1 Products affected

2 Type of change

The inscription at the socket of the fuseholder changes. The voltage rating acc. to UL/CSA is new 600V.

Old inscription	New inscription

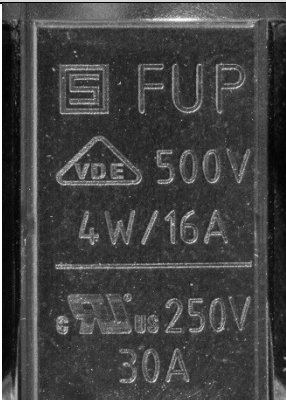
The inscription changes as follows.

The fuseholder FUP has a voltage rating acc. to UL 4248-1 / CSA C22.2 no 4248.1 of 600V (AC/DC). This rating is corrected on the inscription of the socket. Because of this, the layout of the inscription changes.
